DRESSER PUMP
DIVISION

Docket # 03005273
License # 29-02210-02

This is in response to your October 3, 1990 letter citing a violation of 10 CFR Part 2, Appendix C at our facility.

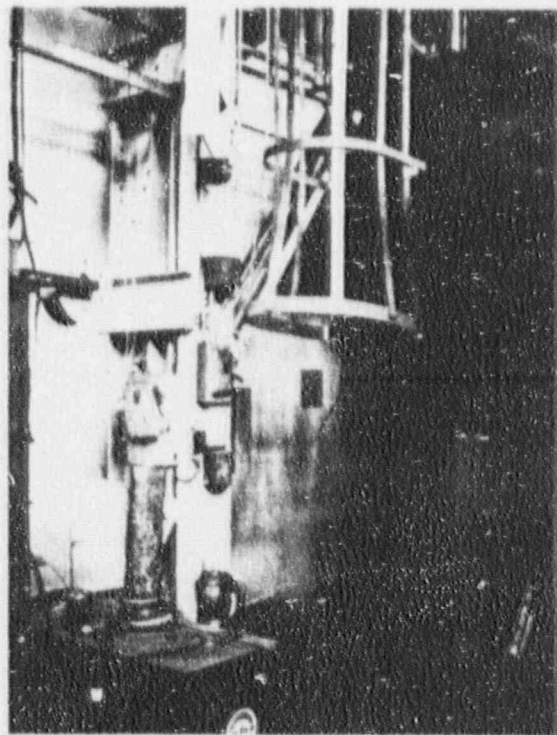
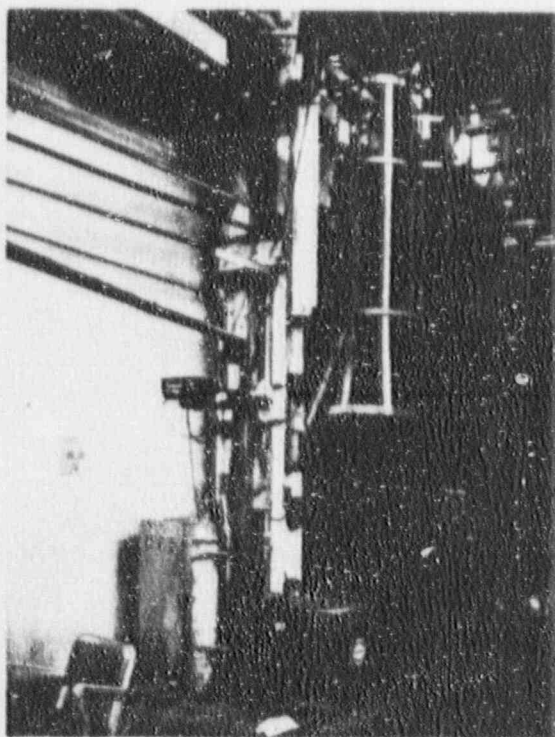
The issue was a built-in access ladder on a large blast cleaning facility located adjacent to the radiographic facility. The inspector contended that it was possible for a person to climb the ladder and, were he agile enough, gain access to the roof of the radiograph room, bypassing the interlocks positioned at the proper access points.

Acknowledging that it would be possible, even through highly improbable, Dresser has physically cut the lower six feet of ladder away from the equipment. "Before and after" photographs are enclosed.
